Re-submittal Form

RESUBMITTAL CONTENTS

VIP PARKING
 23905 EAST 26TH AVENUE
 AURORA, CO

SHEET TITLE:
 LANDSCAPE PLAN

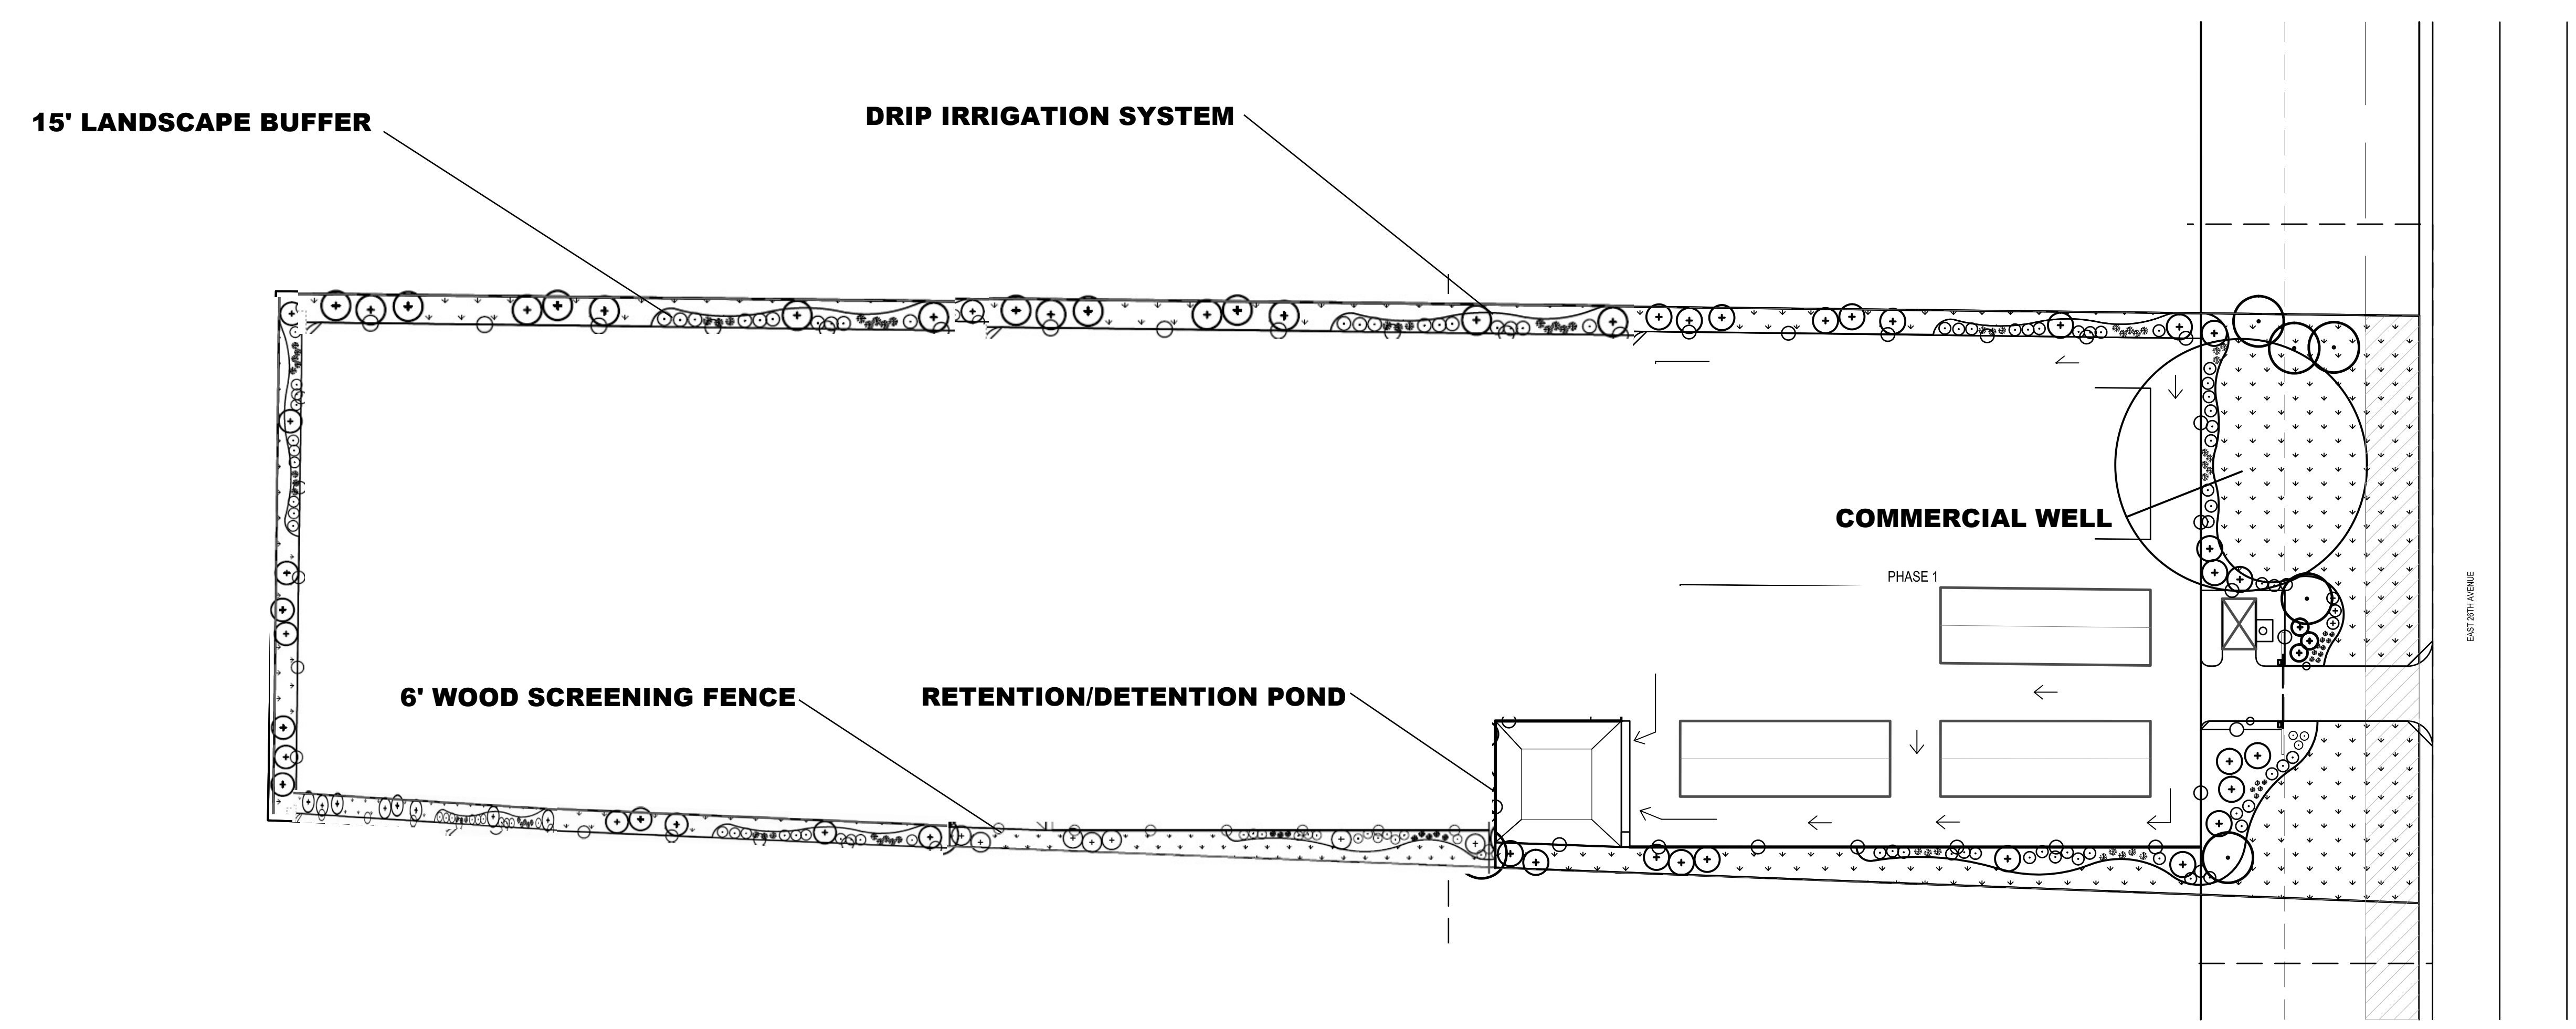
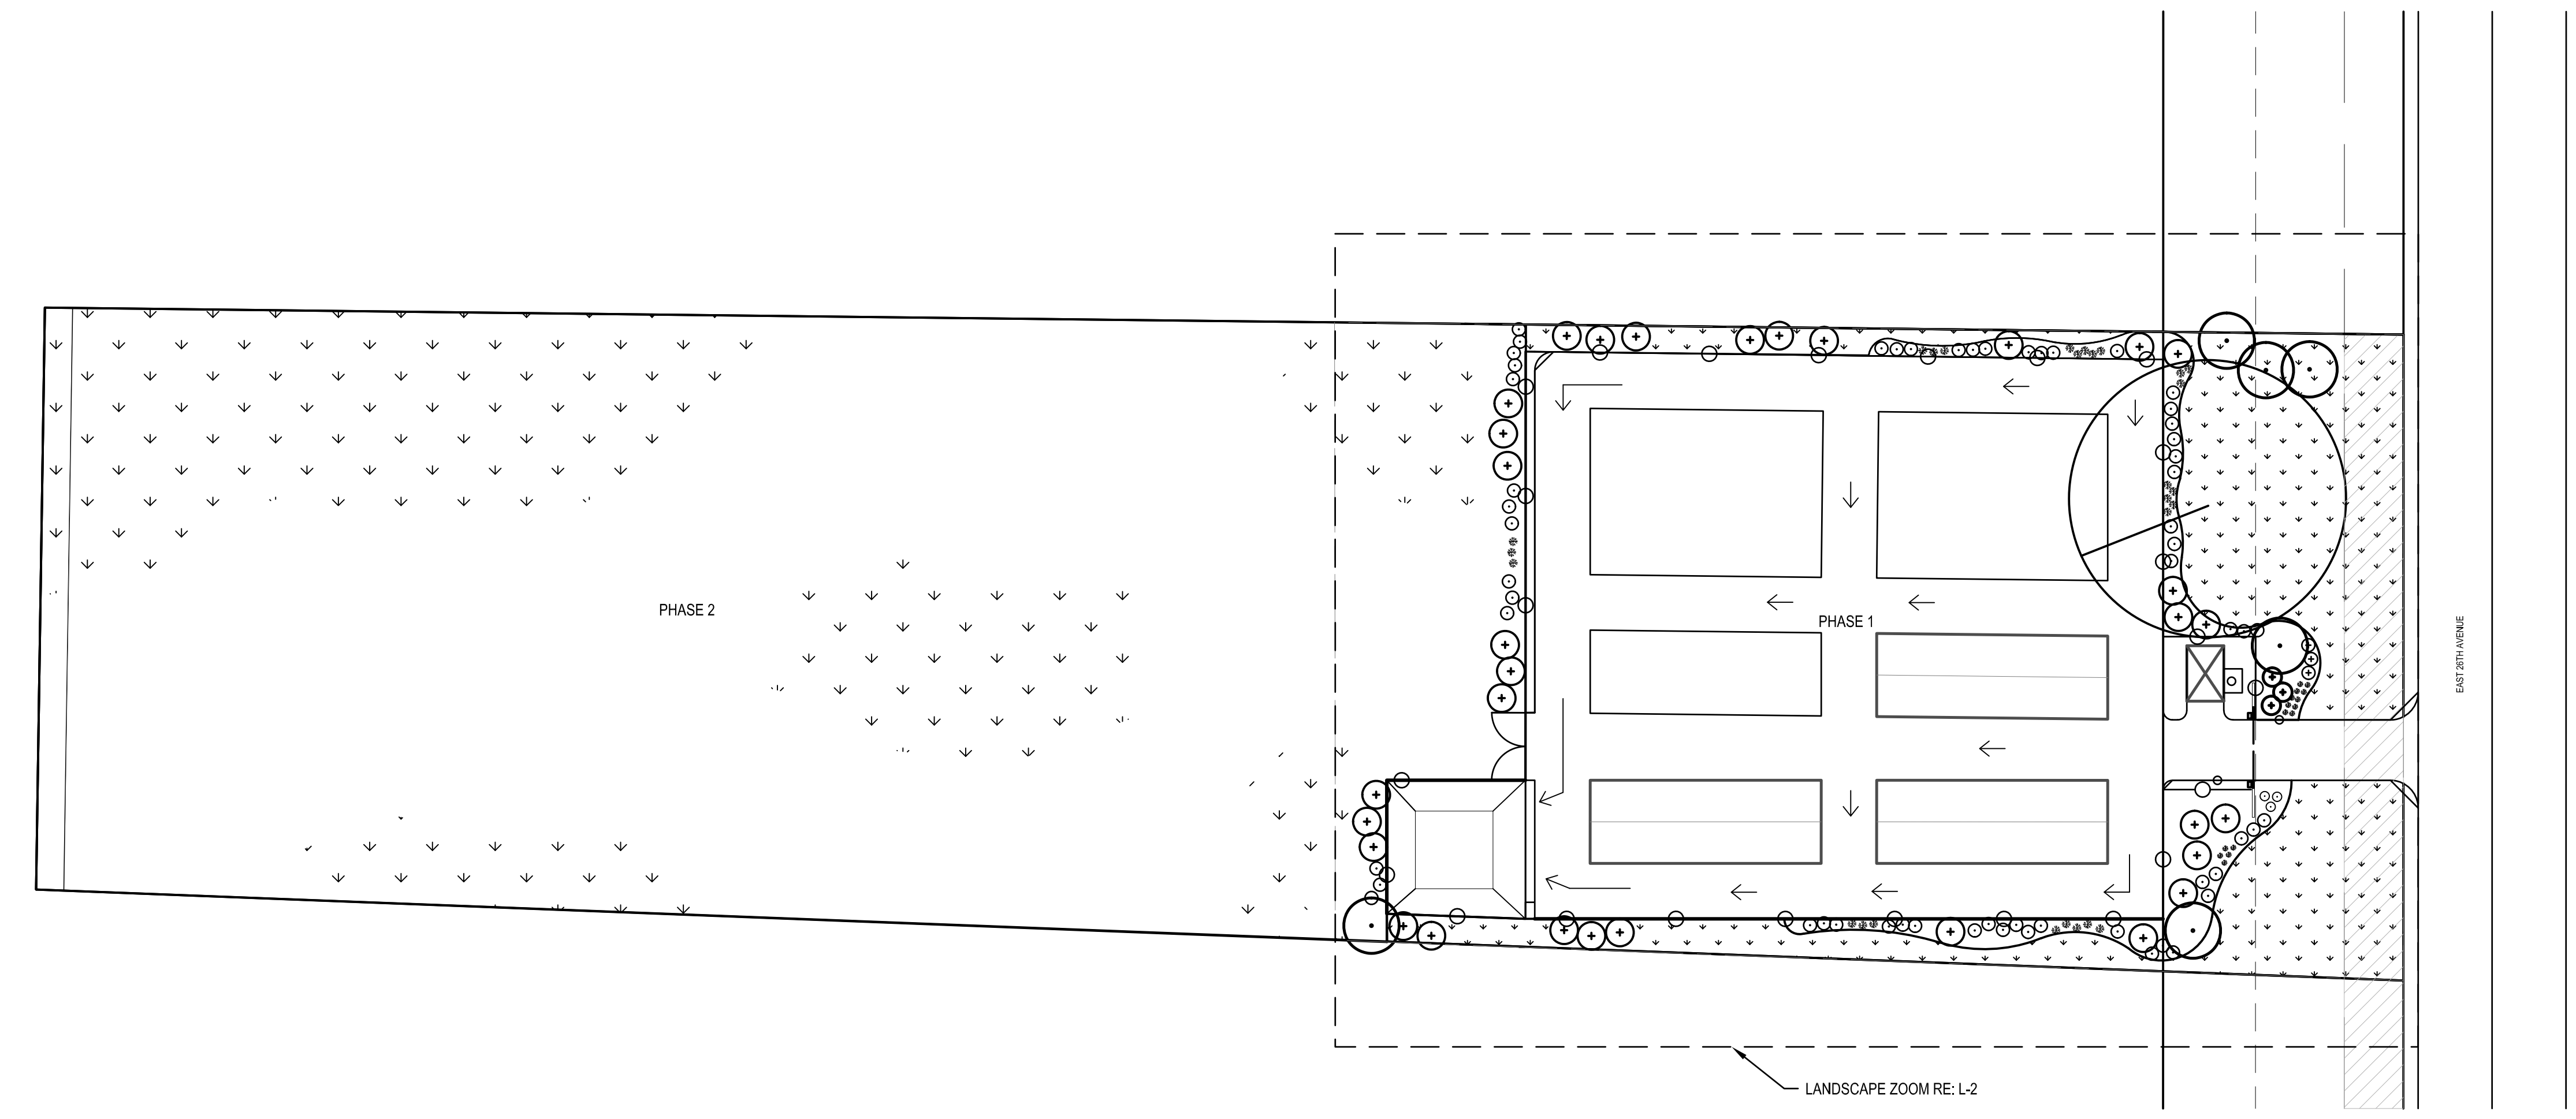
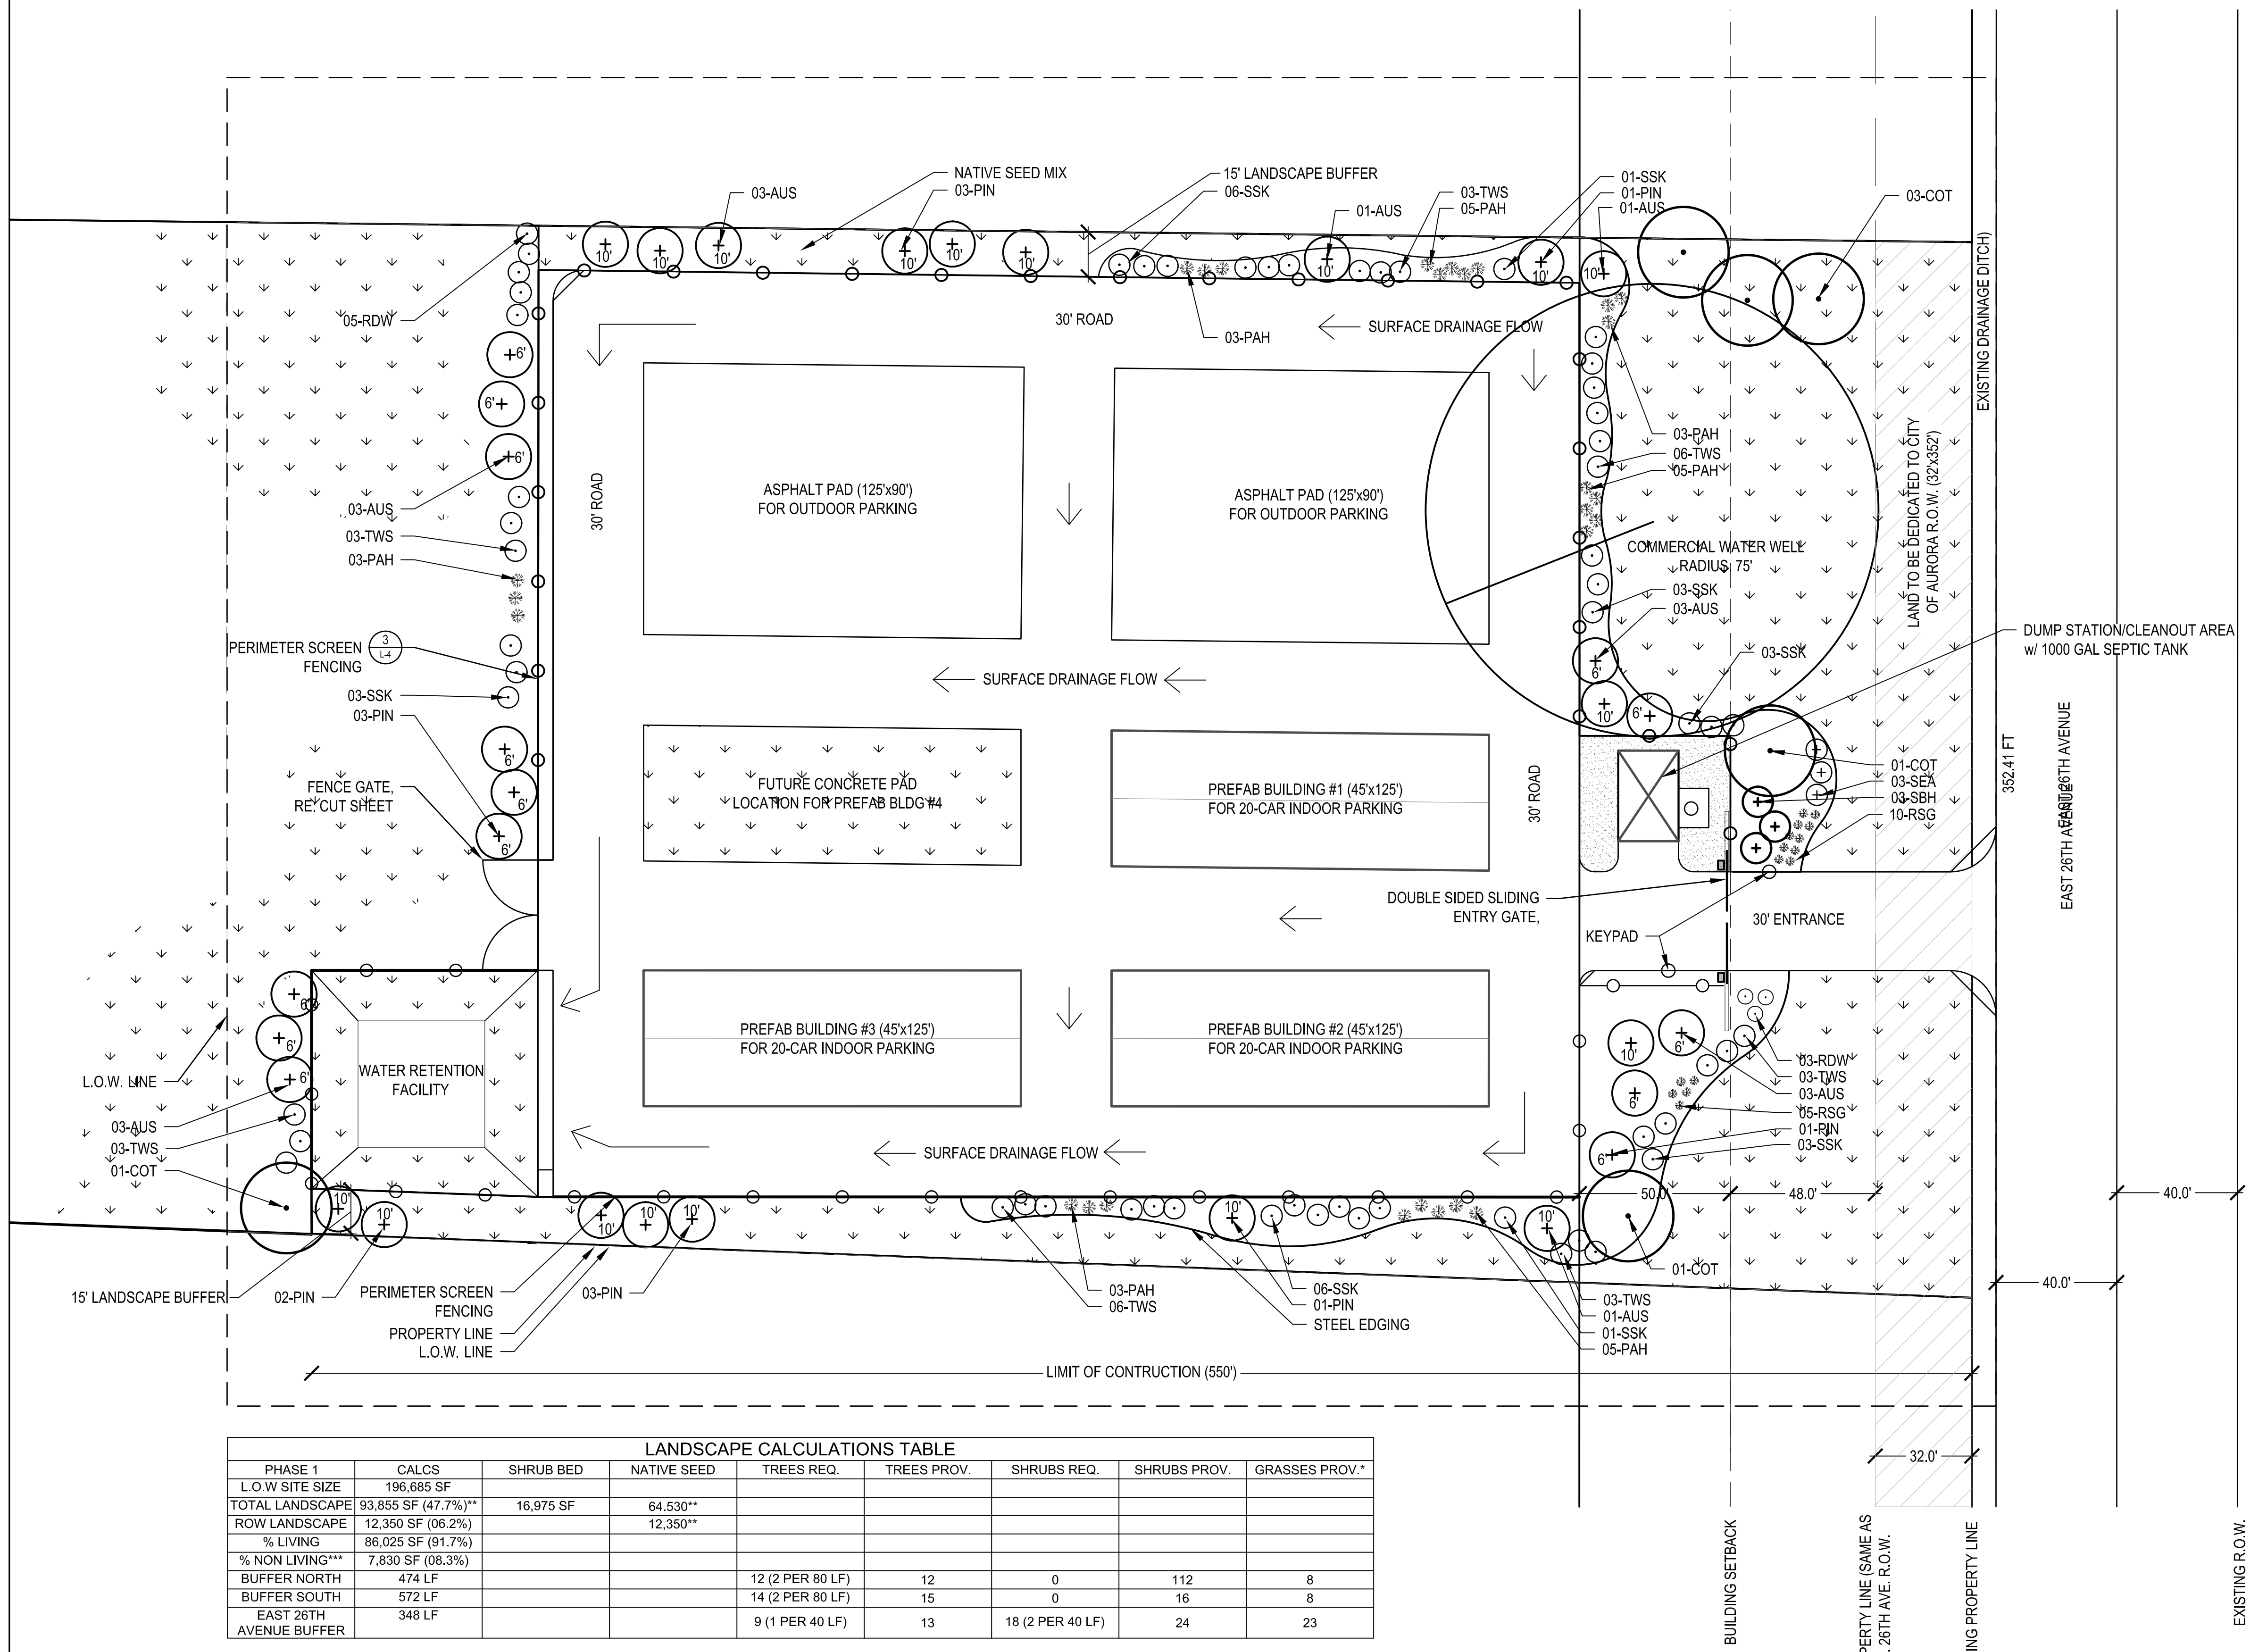
PLN01: Landscaping - need a detailed landscaping plan. Please provide a landscaping plan for the whole parcel, including what was approved in Phase I.
